# PRELIMINARY DRAINAGE REPORT

## GRANDVIEW RESERVE FILING NO. 1

*PCD Filing No.: PUDSP2110*

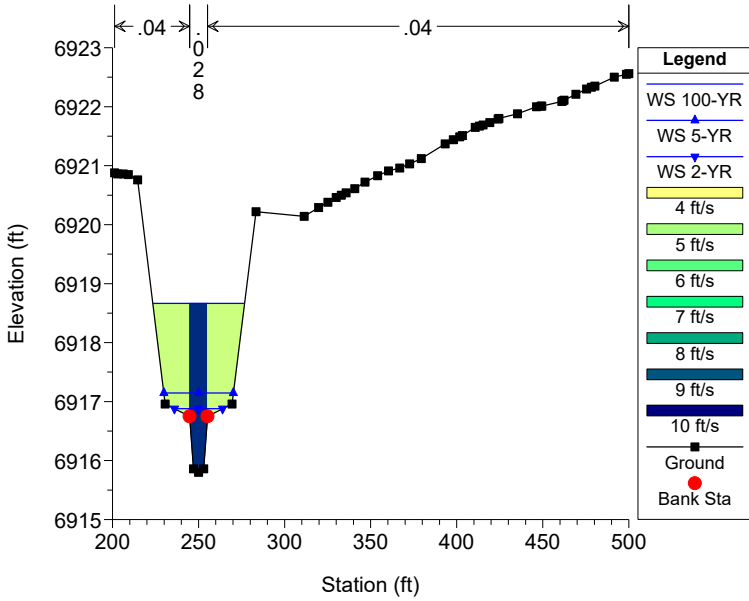
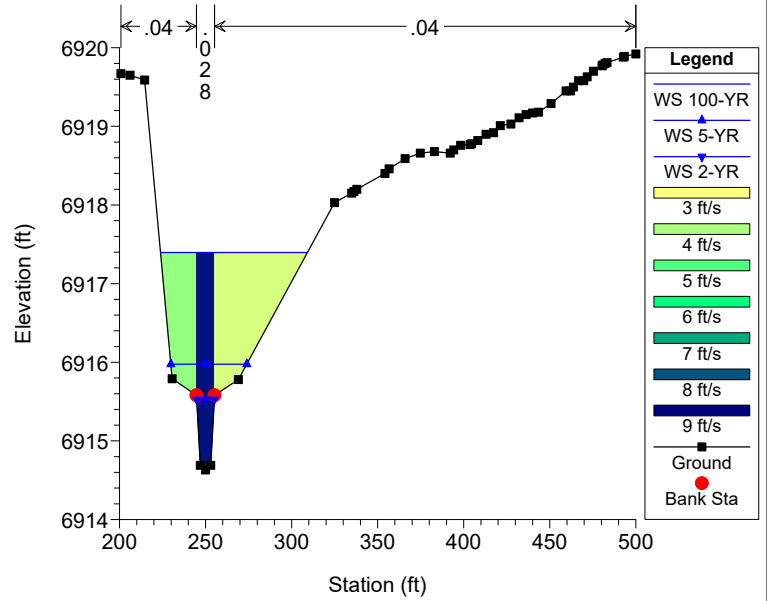
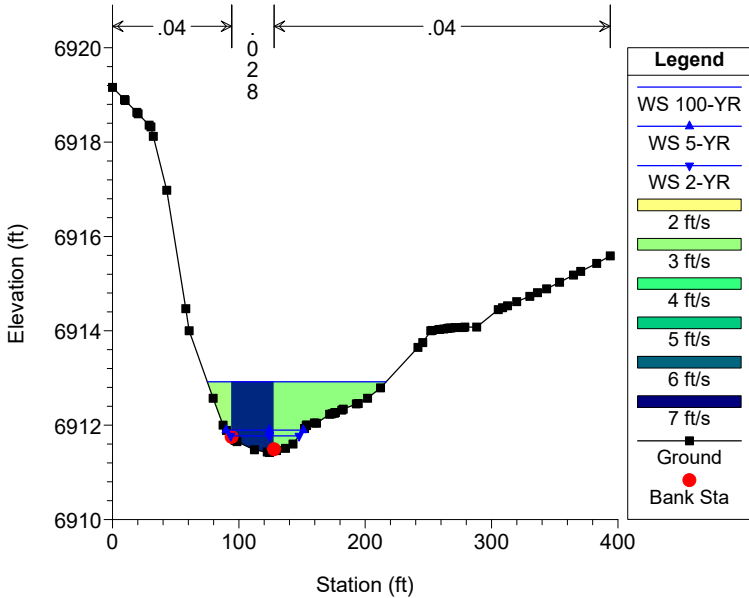
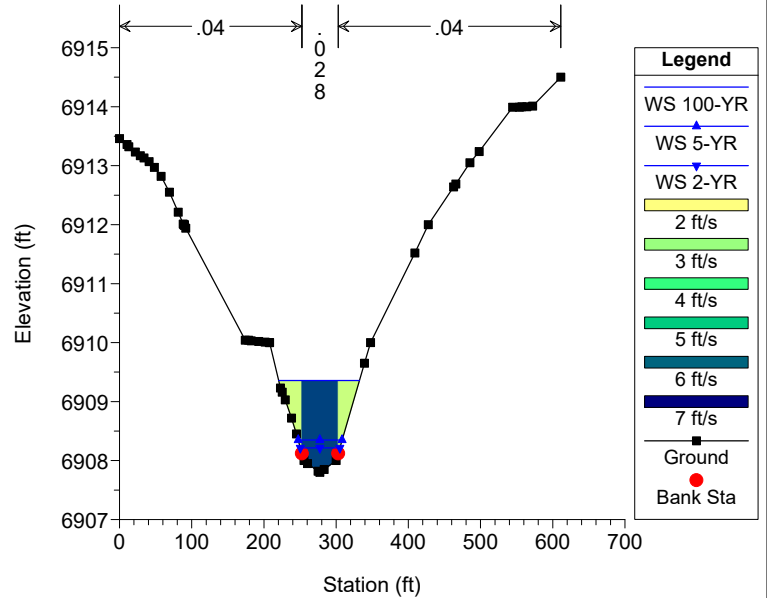
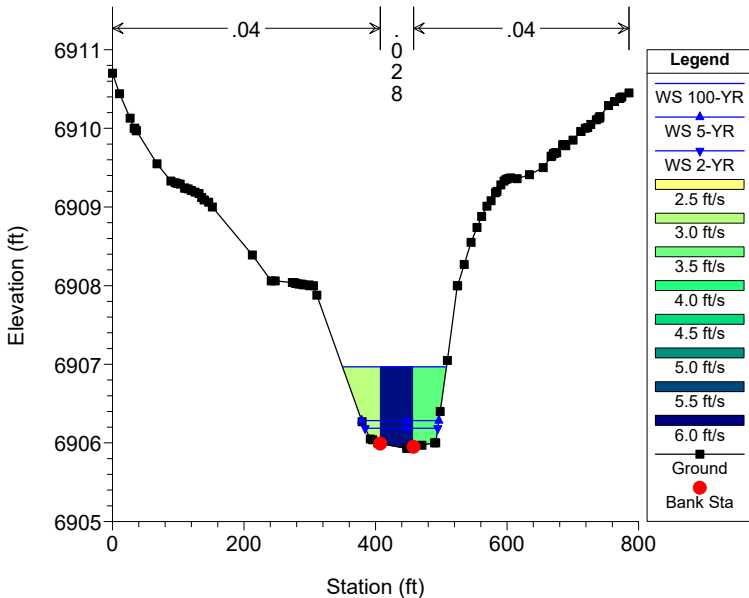
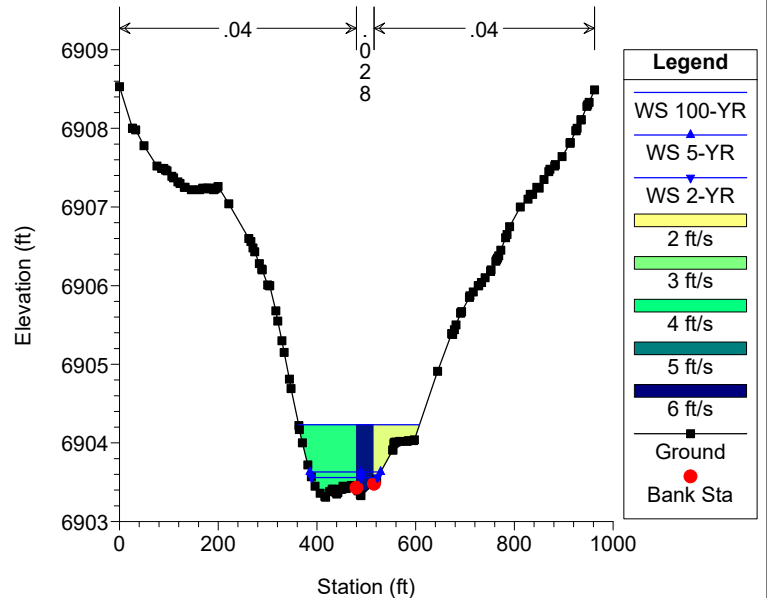
Please only include one set of each item in these appendices. Add a note to the appendix title sheet of whichever is deleted to see the other set in the other report.

Provide HEC-RAS summary tables somewhere in the PDR

**DR-2**  
 Sheet 2 of 3

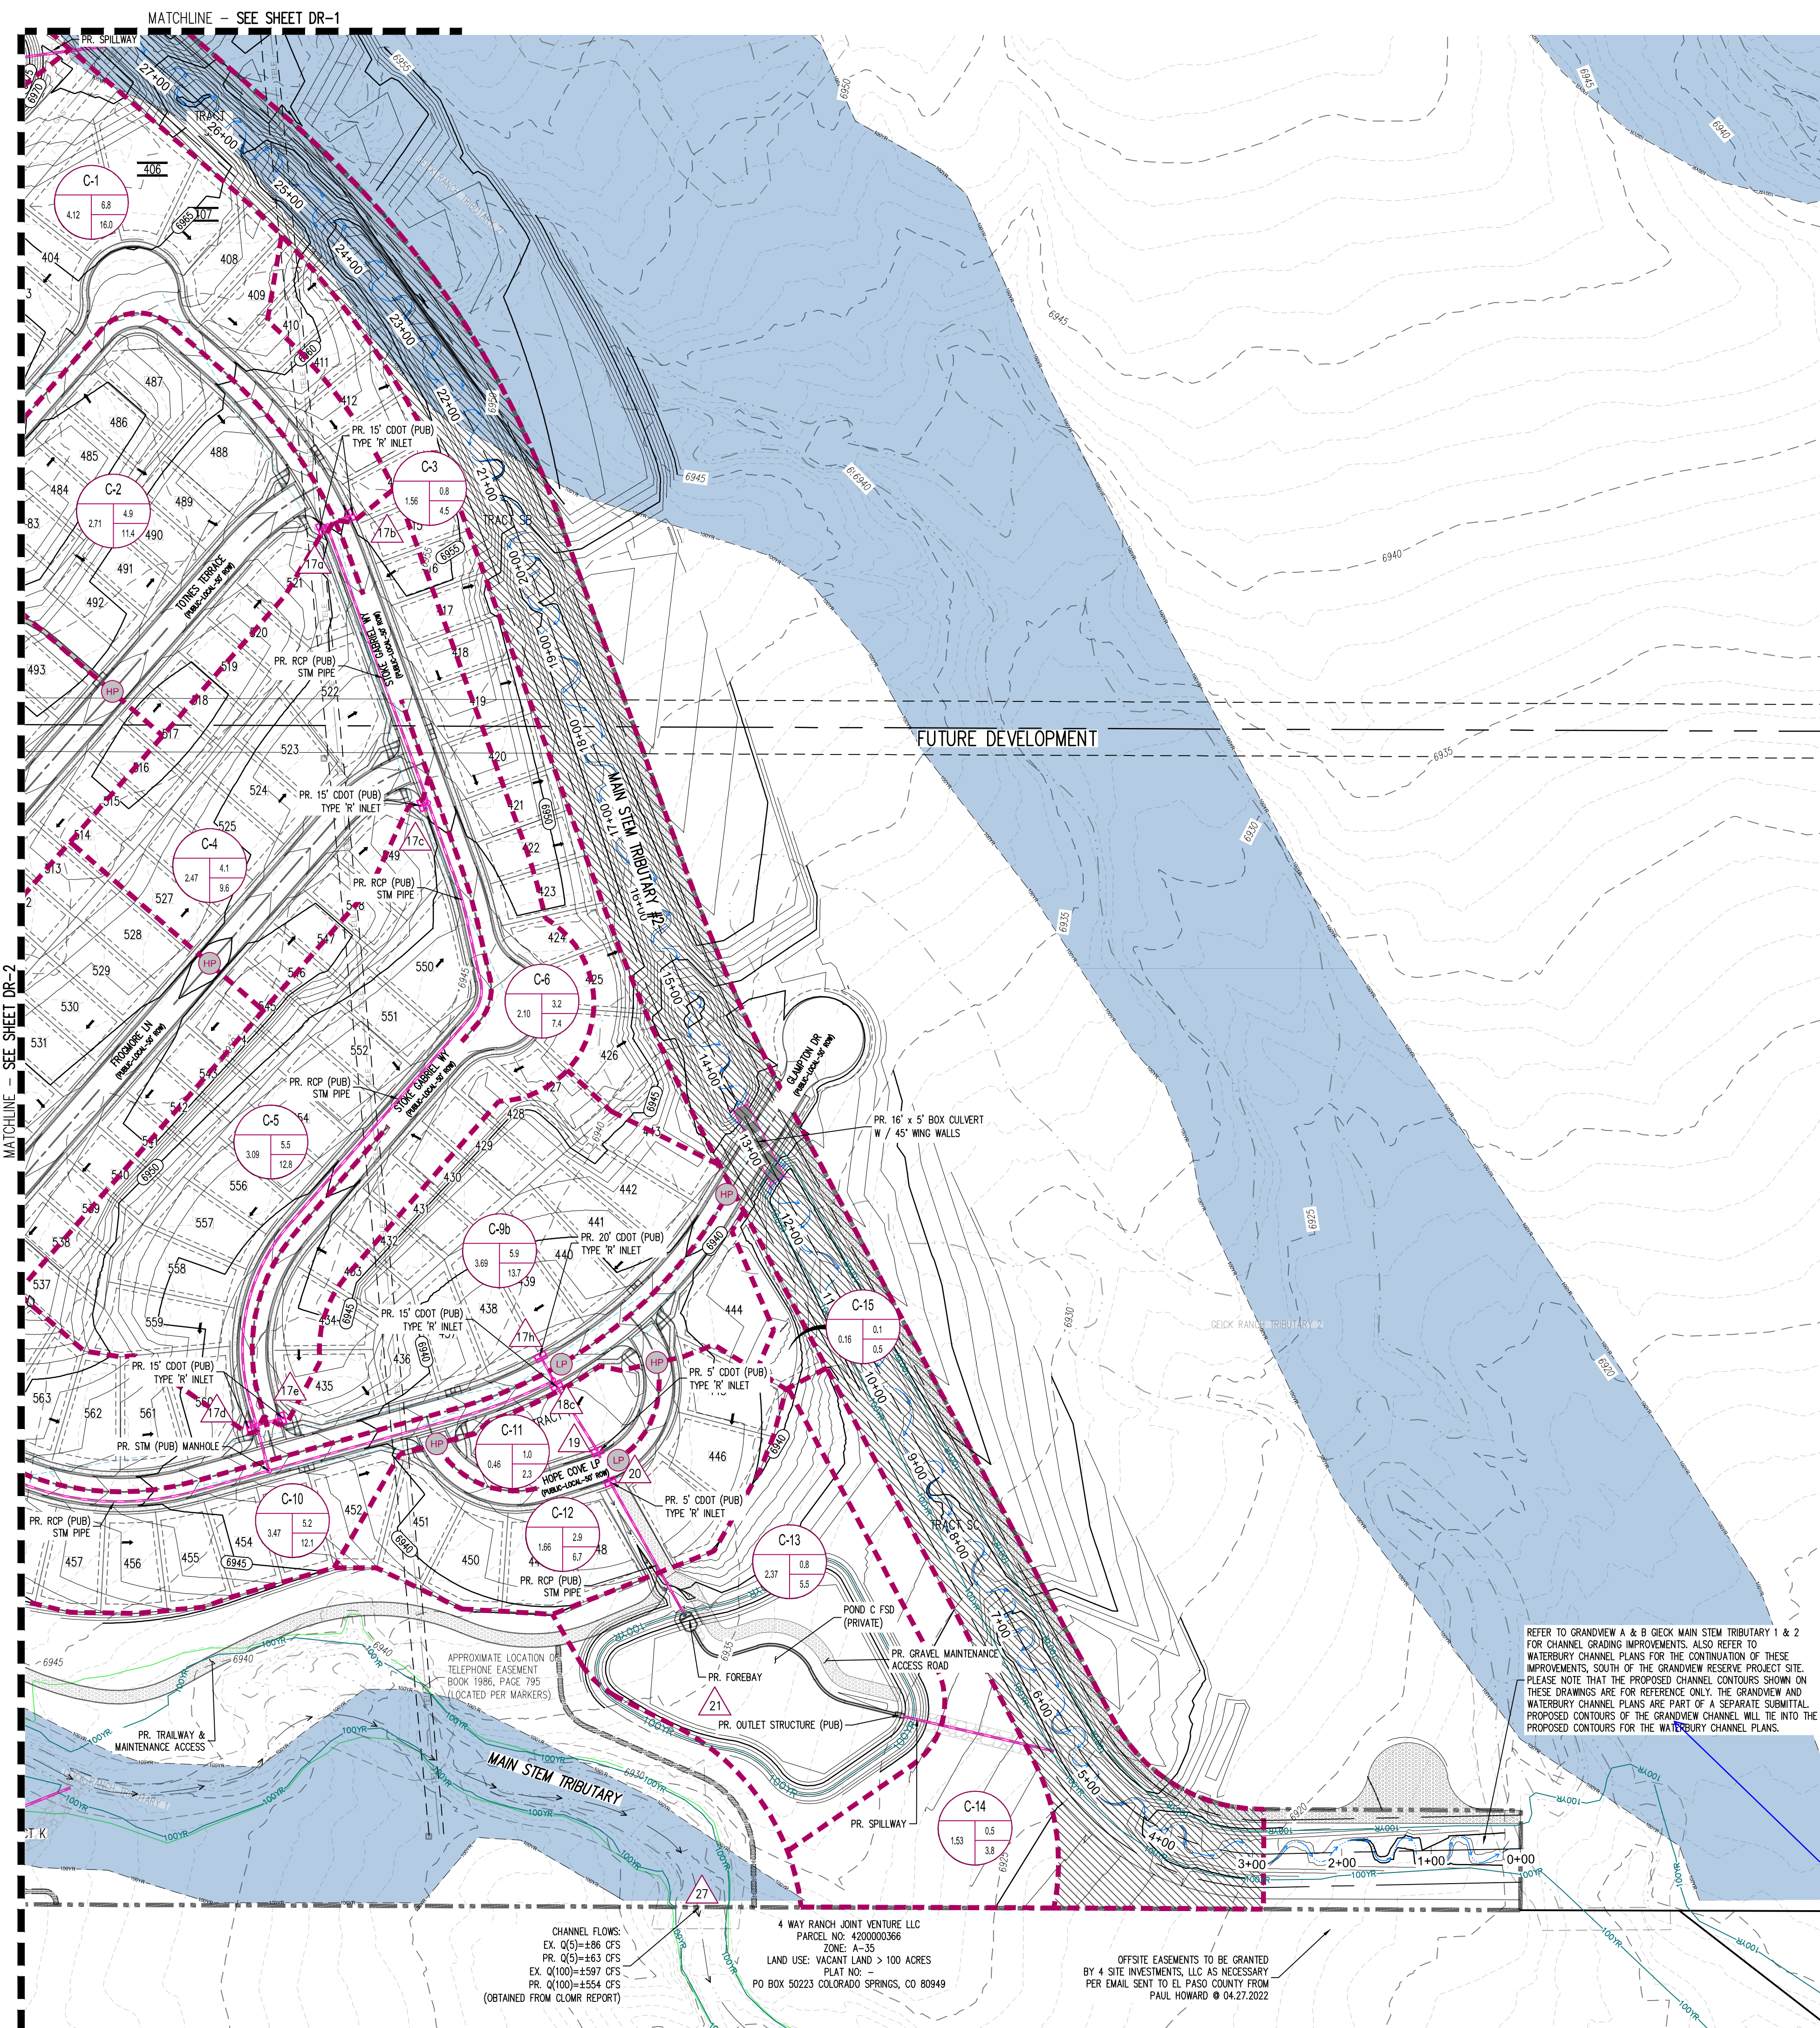
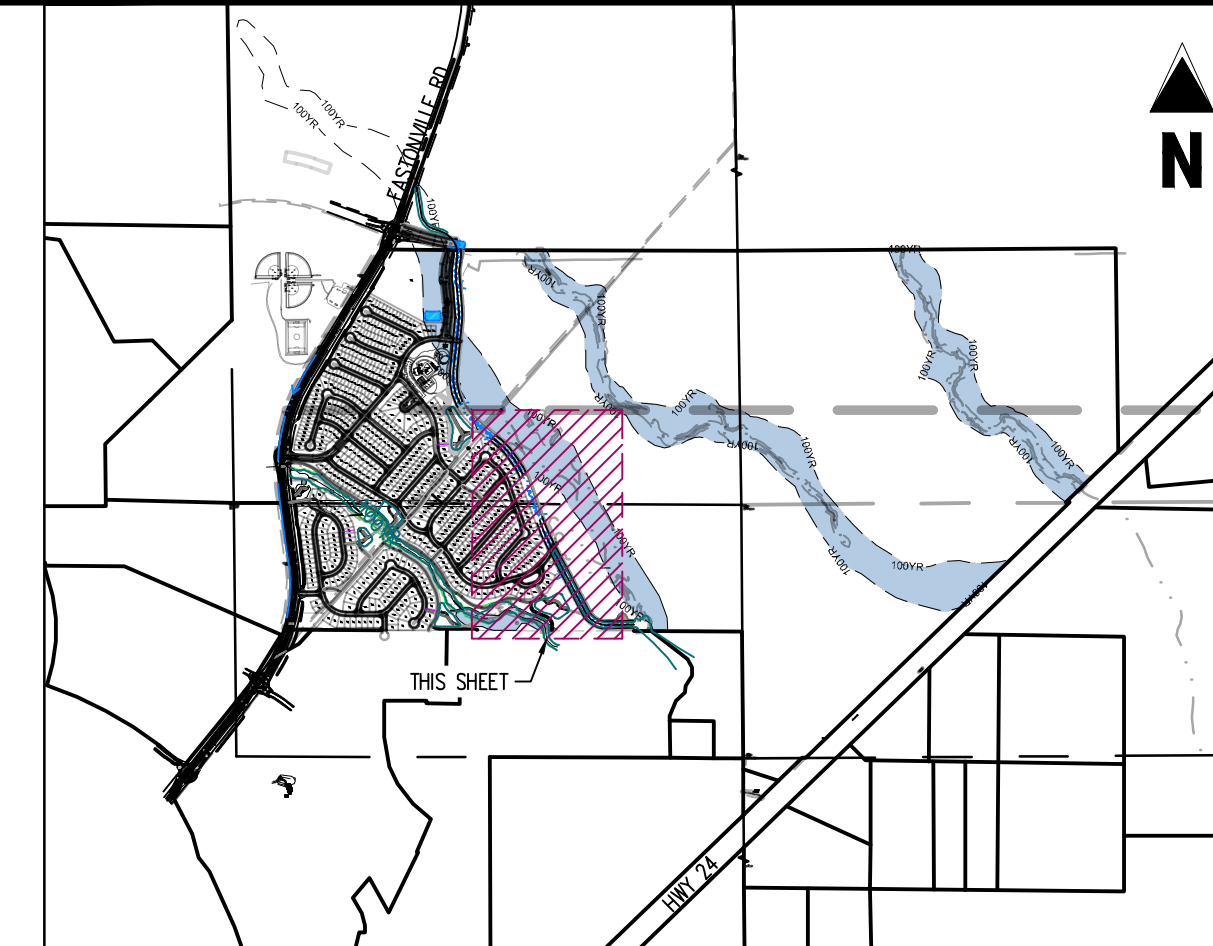
Add a note that 663 cfs should be used for "emergency conditions" analysis, per Meridian Ranch MDDP (or that updated final calculations for offsite flows will be provided in the FDR)
